NATF 496 04
(Relates to SOP No. NATS COL 040)

VENUE LAYOUT REVIEW

This NATF is an official request to a permanent change to a venue layout. To be completed by Lead Nurse on Session			
Date	10 NOV 2022	Session	NEWPORT
Venue Name	BLYTH HALL	Venue Code	DUNWP
Lead Nurse	[REDACTED]	Signature	[REDACTED]

Diagram of Revised Session Layout - please ensure proposed diagram is drawn separately within the space provided (do not use edges of box as e.g. walls)

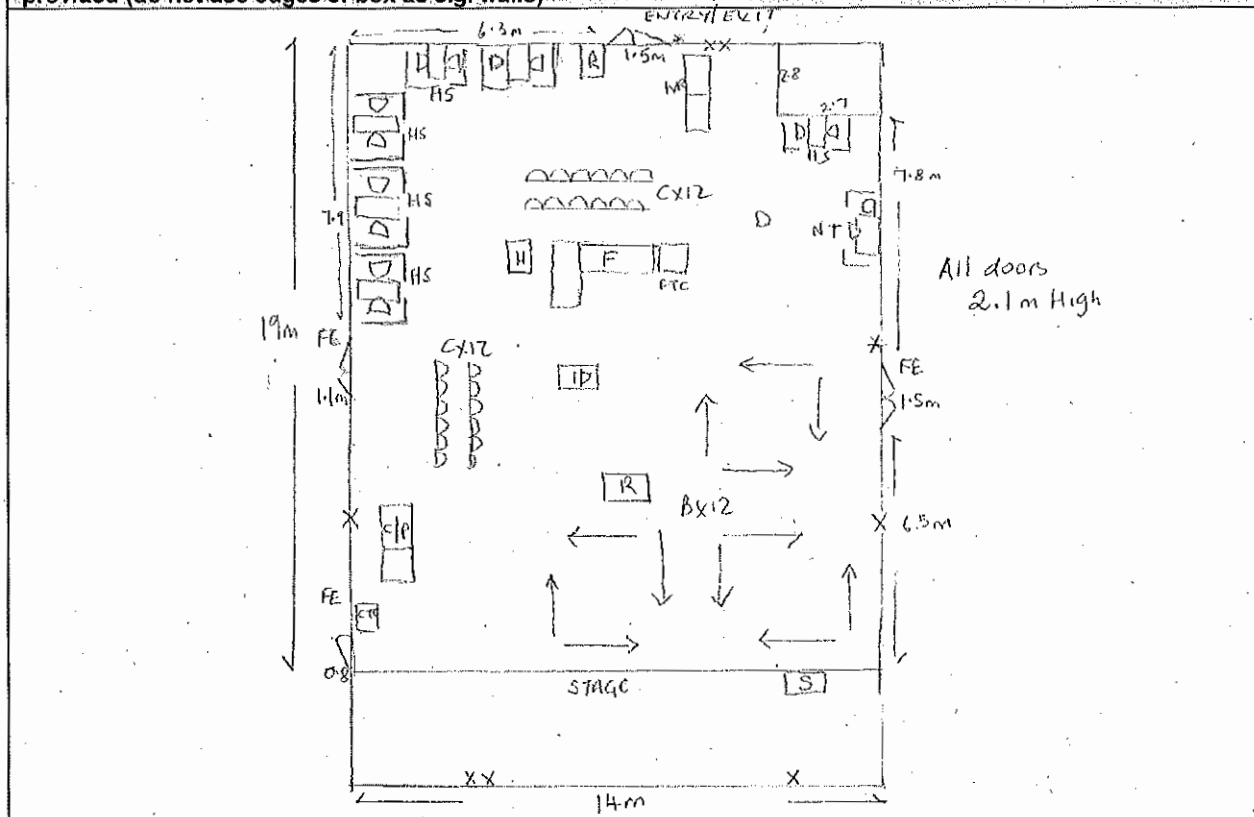
Outline change(s) required / proposed as listed above
CHANGE OF LAYOUT FOR ON SESSION DIGITAL REDESIGN.

Changes to Parking / Access	
Please detail what changes are required to be logged for Parking or Access purposes and why?	
LORRY UNLOADED OUTSIDE HALL, BUT THEN MOVED TO END OF STREET DURING SESSION	
Is change to Parking/Access temporary?	YES/NO
If yes detail time period	N/A 10 NOV 2022

Recommended number of beds	12	Recommended maximum beds for venue	12	Recommended number of Booths	6
----------------------------	----	------------------------------------	----	------------------------------	---
